9320300 NONMETALLIC ACCESSORY MATERIALS FOR CONCRETE PAVEMENT AND CONCRETE STRUCTURES
COMMENTS FROM INTERNAL/INDUSTRY REVIEW

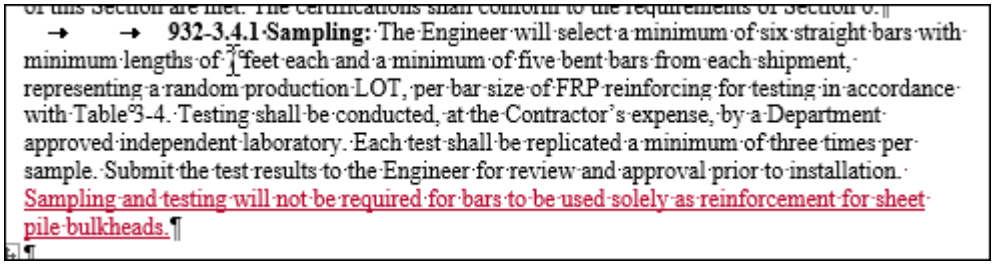
Comments: (7-15-19, Internal)
I understand the rationale behind this; however I'm not in favor, as there could be a billet of bars that arrive onsite that are purposed for more than sheet pile bulkheads which are part of the same LOT. Suggest deleting.
